APPROVALS:	DATE	Compressor Controls Corporation 11359 Aurora Ave. - Des Moines, IA 50322	
DRAWN Tom Stoll	7/22/99	IOC-555 Rev. C Healthy Control PLD Main Logic	
CHECKED		TARGET REF. DES. U43	DWG NO XX-XXXXXX-XXX
ENGINEER Tom Stoll	4/10/00	FILE HL_U43D	Sheet 1 of 2

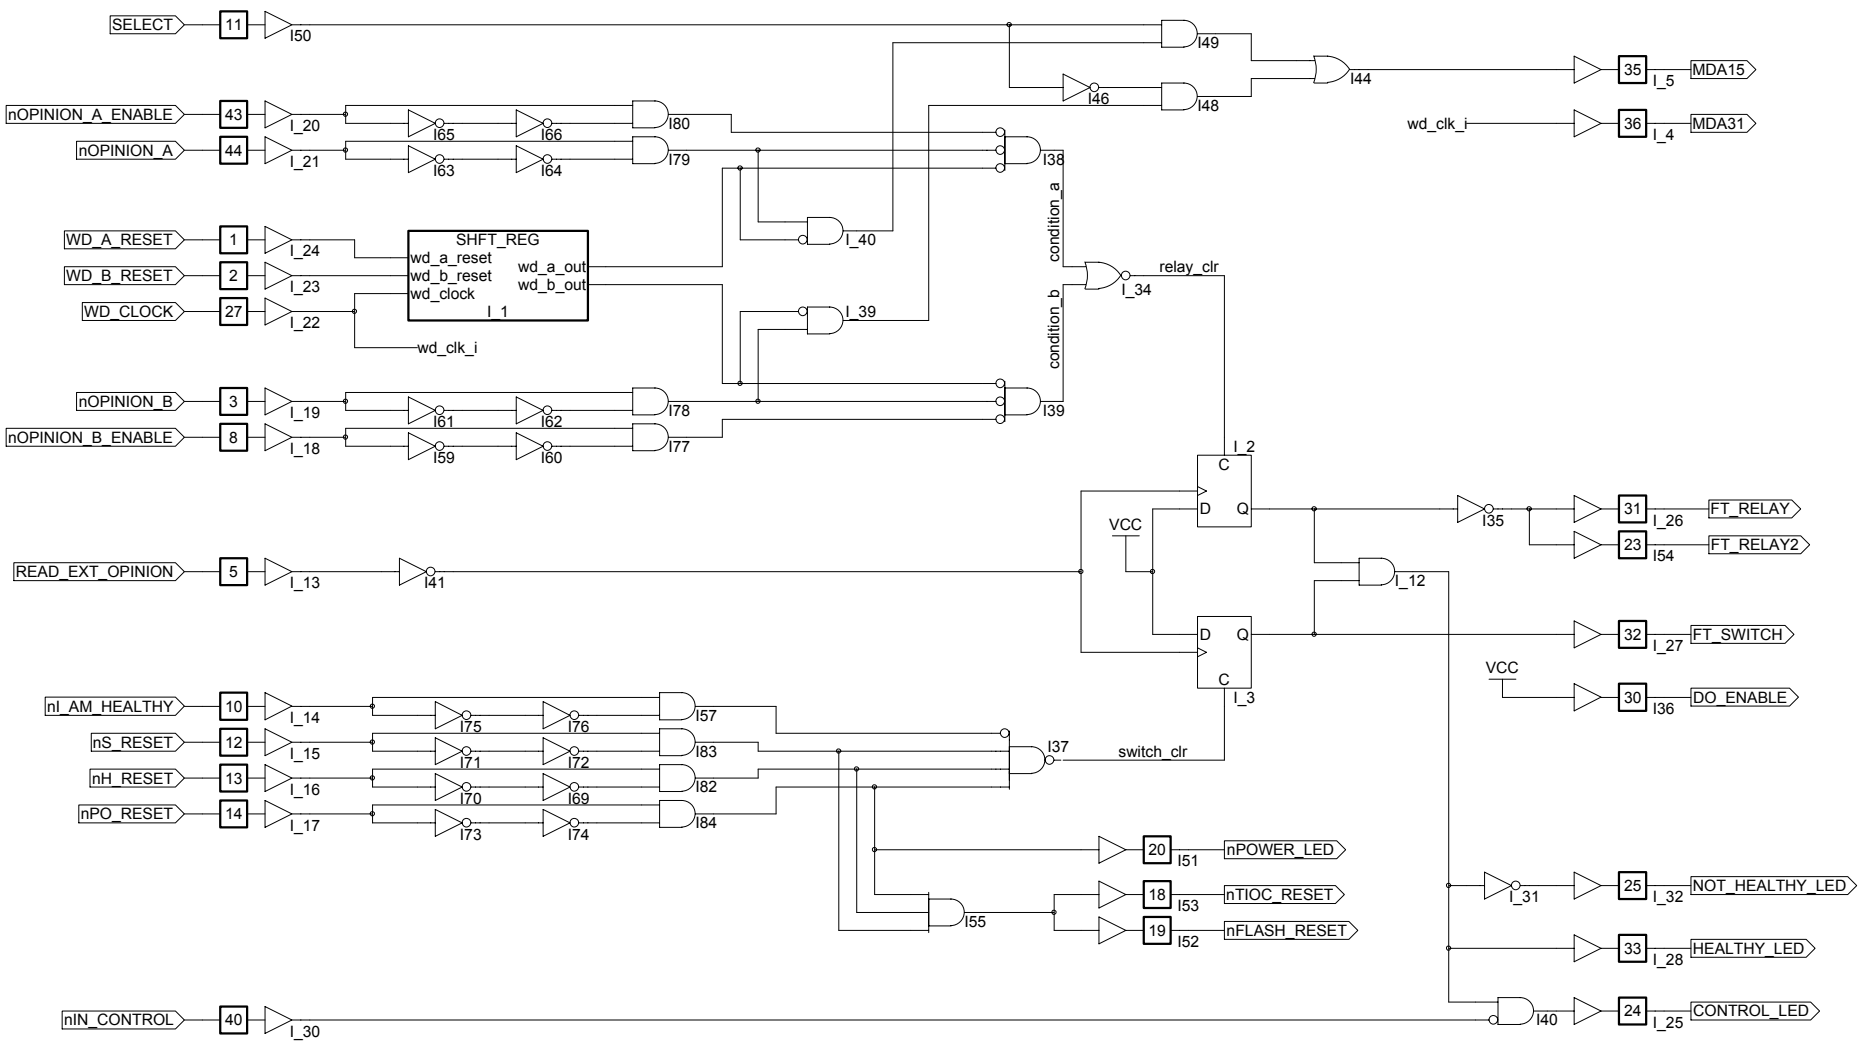
Rev. B - Remove PO_Reset Delay 08/21/01
Rev. C - Change DO_ENABLE connection from FT_SWITCH to VCC 10/15/02
Rev. D - Add FT_RELAY2 for current, Reset outputs, and glitch filters on inputs 01/05/05
